Service Letter

Number: L02-01 A

Subject: Fuel Injector Crack Inspection of older SA52000-A1 cylinder stud assemblies.

Figure 1

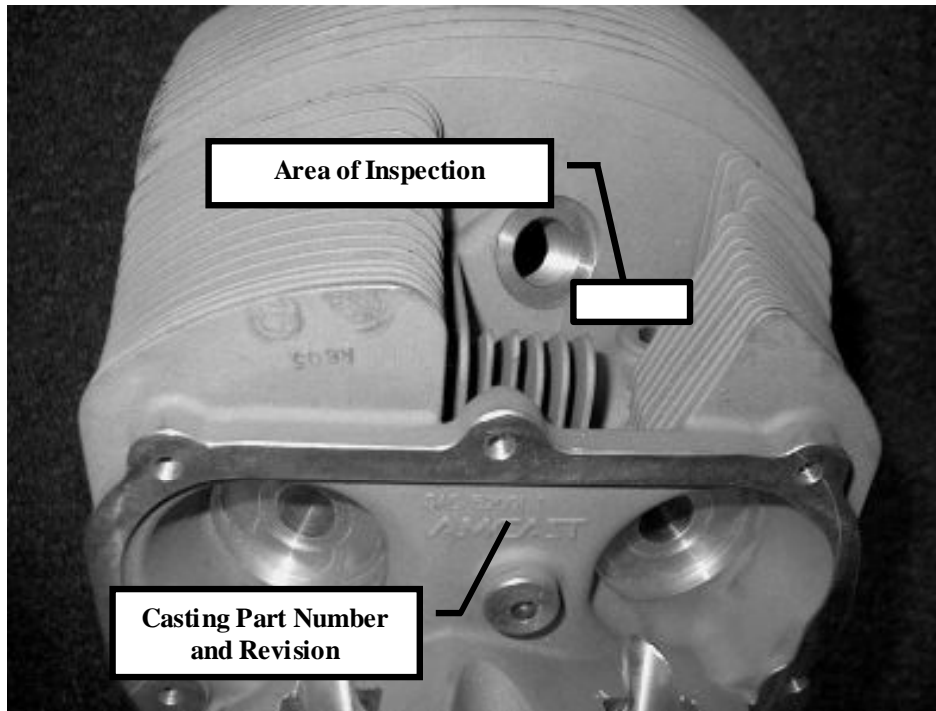
This Service Letter covers inspection of Superior Air Parts, Inc. SA52000 series Millennium® cylinders for cracking between the radius, below the fuel injector boss and the upper spark plug boss (see Figure 1). A small number of early models of Superior's 520 cylinder heads have been reported to crack in this area. This type of cracking has previously occurred on TCM 520 engines and mechanics have historically inspected this area for indications regardless of cylinder manufacturer. The purpose of this Service Letter is to recommend that early models of Superior's 520 cylinders be included in this inspection. Only Superior 520 cylinders manufactured before May 2000 and manufactured with castings identified as SAC52001I or SAC52001I B are susceptible to this cracking. The casting identification can be found in the rocker box area above the valves, as seen in Figure 1. Later castings manufactured by Superior Air Parts have had no reports of cracking.

Inspect applicable cylinders in the area shown in Figure 1 at every 100 Hour Inspection. The area is easily visible and should require no additional labor during the usual visual inspection. If any indication of cracking is found during inspection remove and replace the affected cylinder.

Figure 2

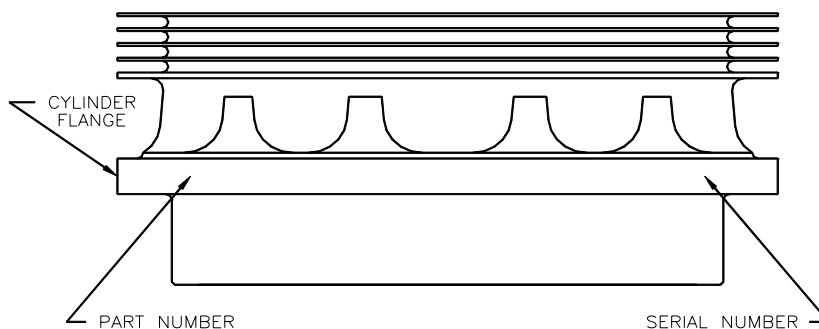
Cylinders that fall within Superior's warranty period may be submitted to a Superior Air Parts' Distributor for Warranty consideration. The cylinder's part number and serial number are identified on the cylinder flange, as shown in Figure 2. If a specific procedure is not addressed in this Service Letter, the applicable procedure in the original equipment manufacturer's current overhaul manual applies.
